Service Bulletin

Bulletin No.: 21-NA-097

Subject: Rattle or Buzz Noise from Instrument Panel Area

5812549

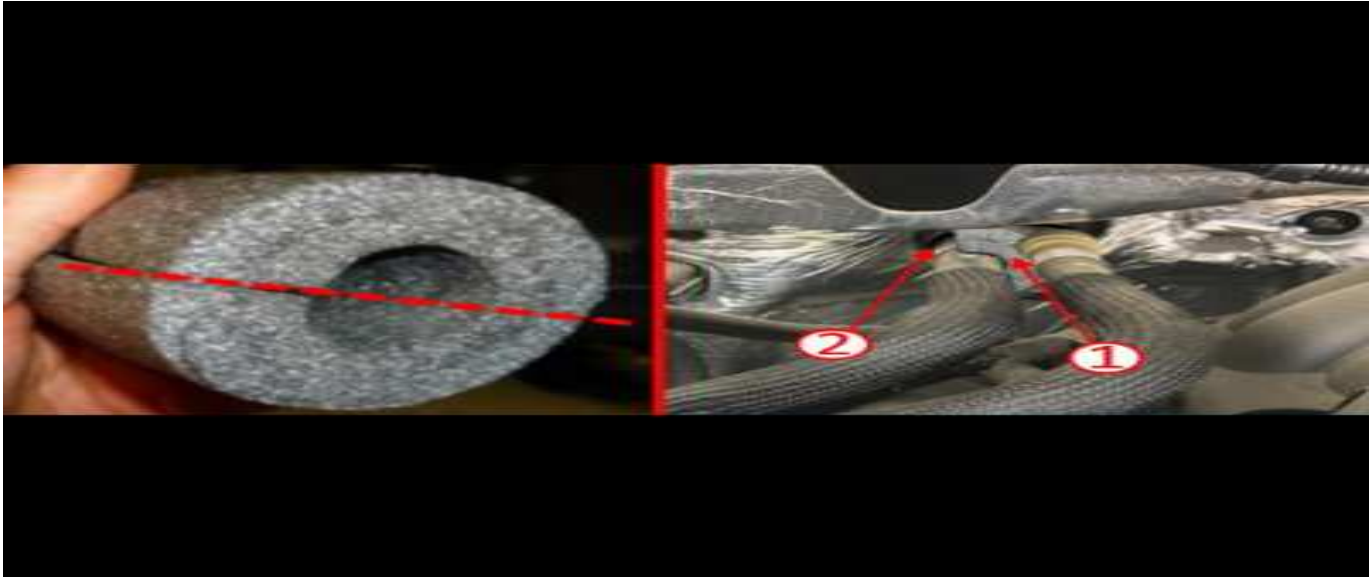
Involved Region or Country	North America, Middle East, Israel, Palestine.
Condition	Some customers may comment on a rattle/buzz type noise from the center instrument panel area.
Cause	 <p style="text-align: right; font-size: small;">5812781</p>
Correction	This condition may be caused by the heater core pipes contacting the HVAC case. Install a foam insulator between the heater core lines.

Note: Open cell foam hot water plumbing insulation was the chosen material for this repair.

1. Cut the plumbing insulation approximately 3 inches (76 mm) in length.
2. Cut the insulation circumference in half as shown in the graphic above.
3. Insert the half sleeve between the inlet and outlet of the heater core pipes (1).
4. Utilizing a tie strap (2), gently secure the foam piece between the heater core inlet and outlet connectors.
